**ADDENDUM NO. 01 – PORTAGE PUBLIC SCHOOLS – HAVERHILL ELEMENTARY SCHOOL BP 5:  
FOOTINGS AND FOUNDATIONS**

## ADDENDUM NO. 1 [BP 5]

<b>DATE OF ISSUANCE:</b>	June 15, 2023
<b>PROJECT:</b>	<b>Haverhill Elementary School Bid Package 5: Footings and Foundations</b> 6633 Haverhill Avenue Portage, MI 49024
<b>OWNER:</b>	Portage Public Schools
<b>ARCHITECT'S PROJECT NO.:</b>	21-237.25
<b>ORIGINAL BID ISSUE DATE:</b>	May 25, 2023

**1 FOUNDATION PLAN**  
 3/32" = 1'-0"

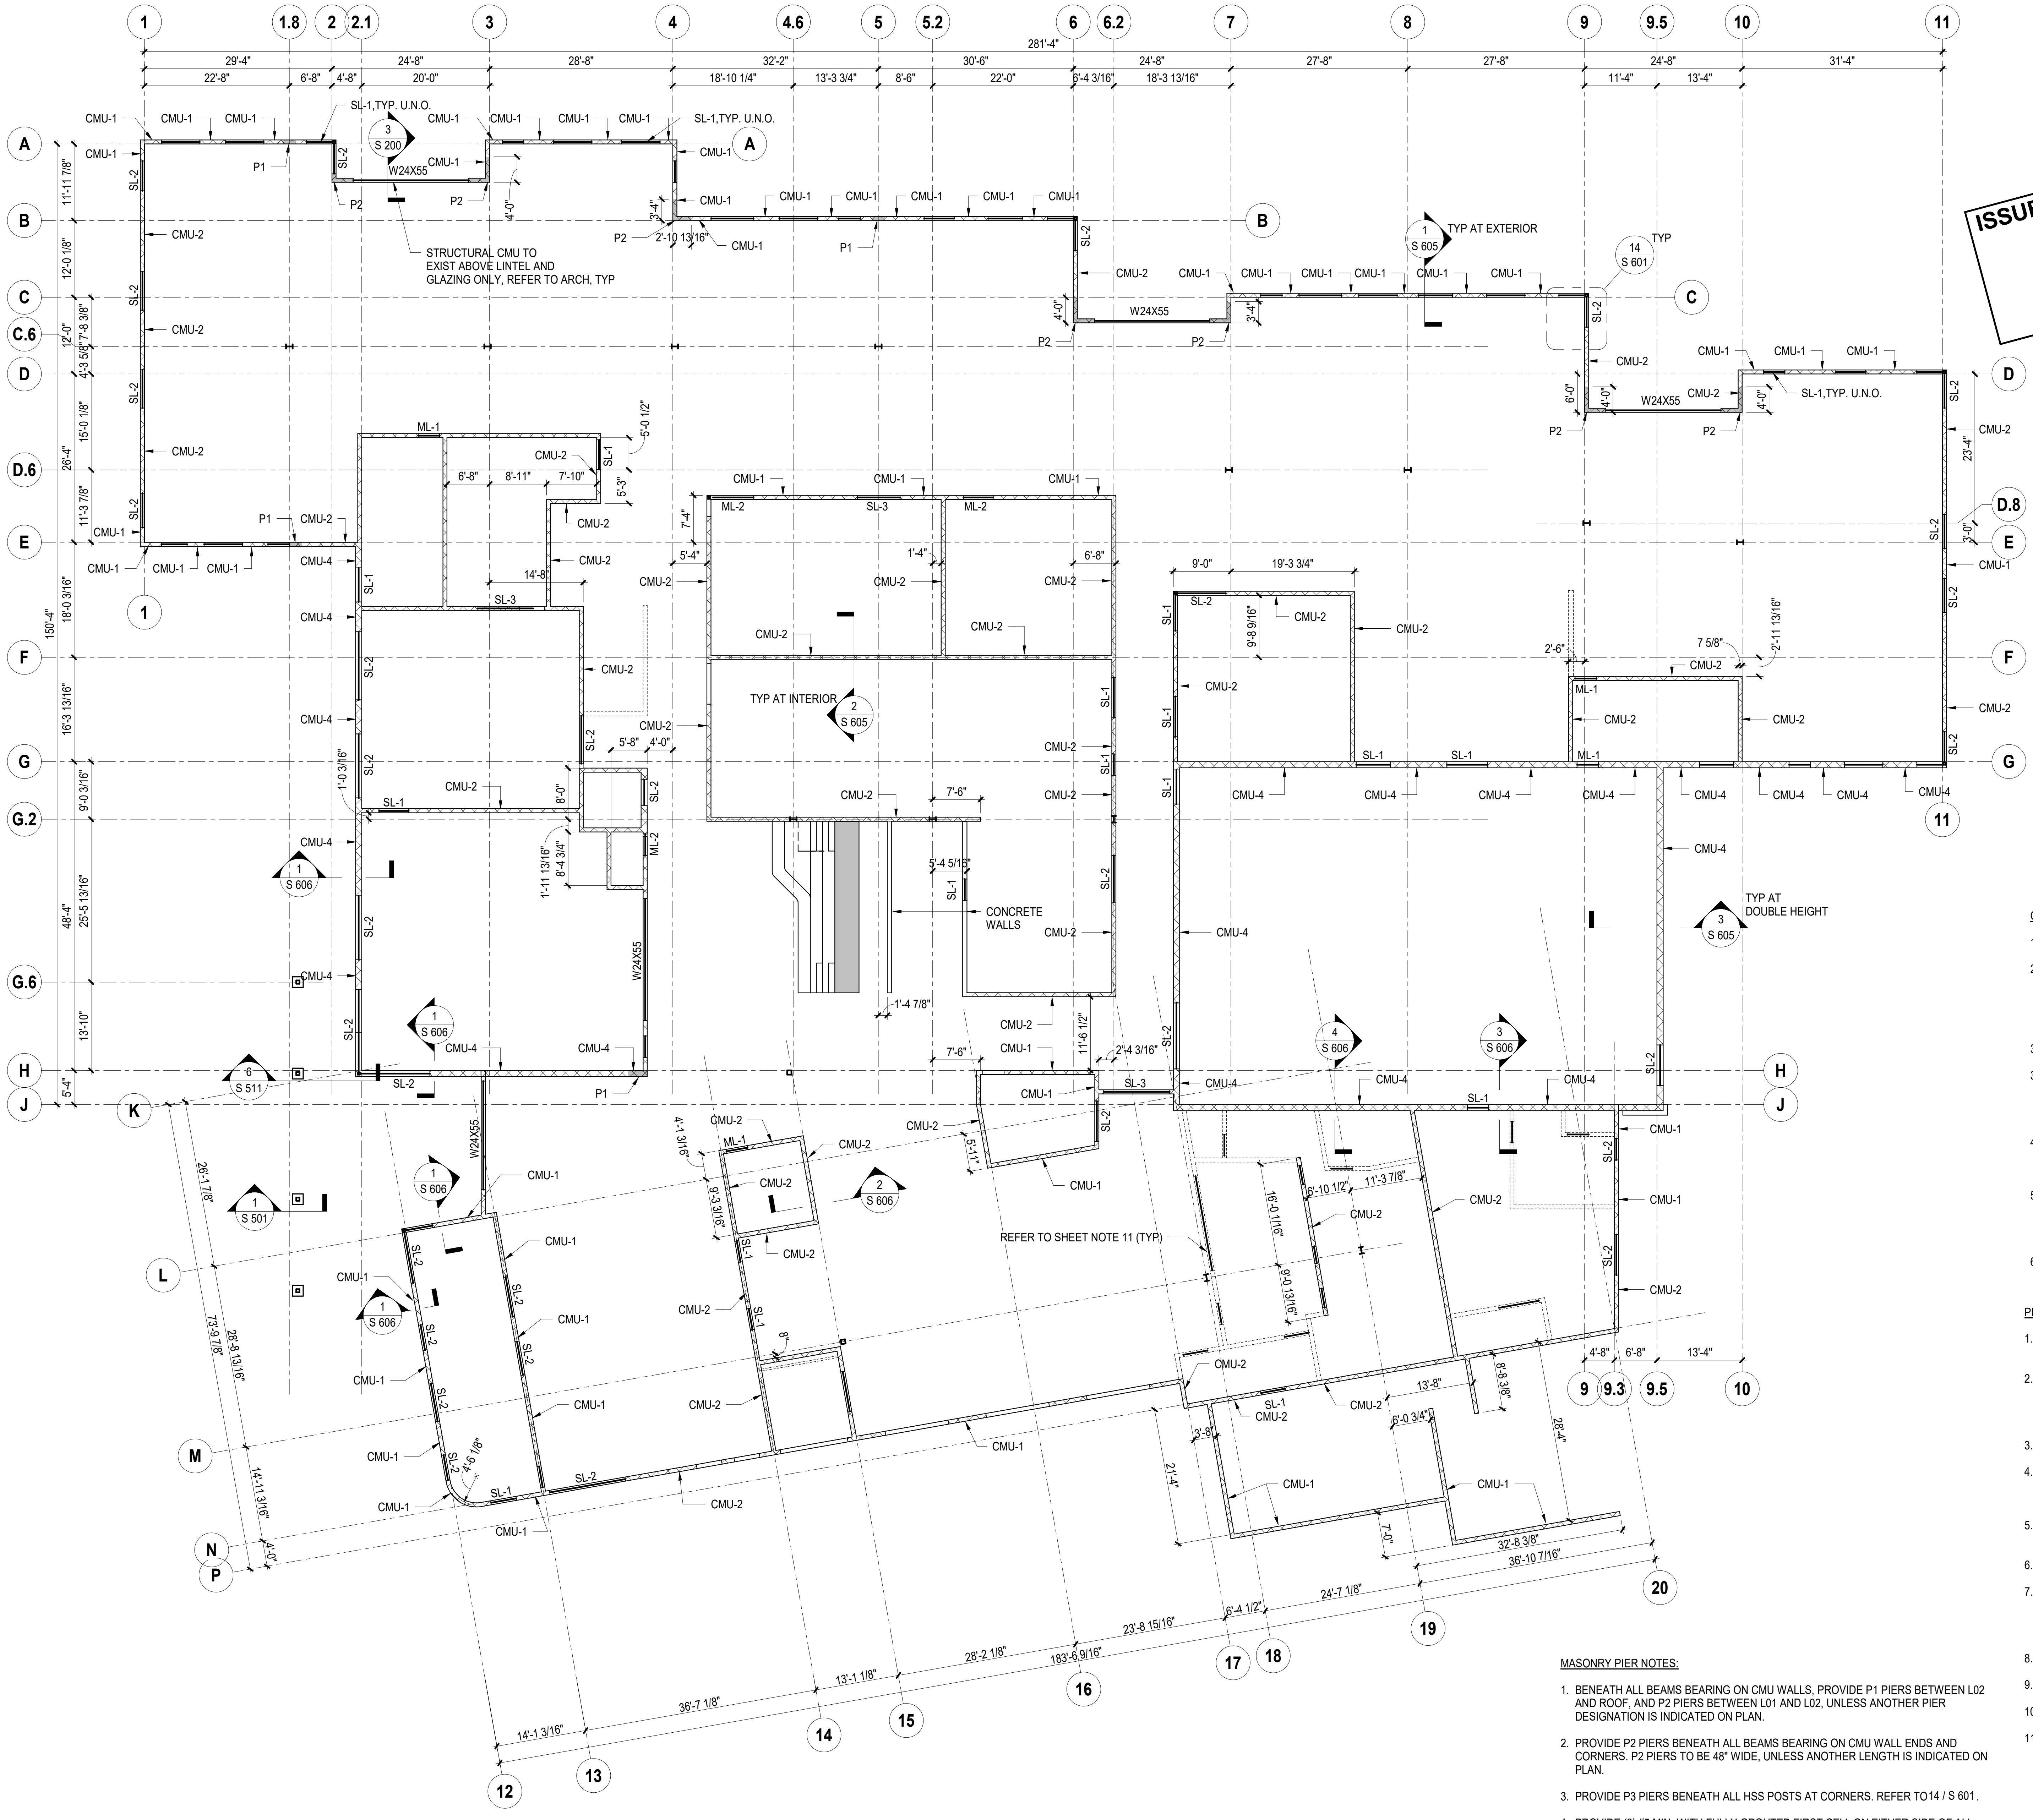
Refer to Sheet(s): S100

- Revised screen wall at the external mechanical equipment
- Added concrete piers at the canopy post footings
- Shifted Gathering stairs and supporting footings to match arch
- Clarified wall footing dimensions
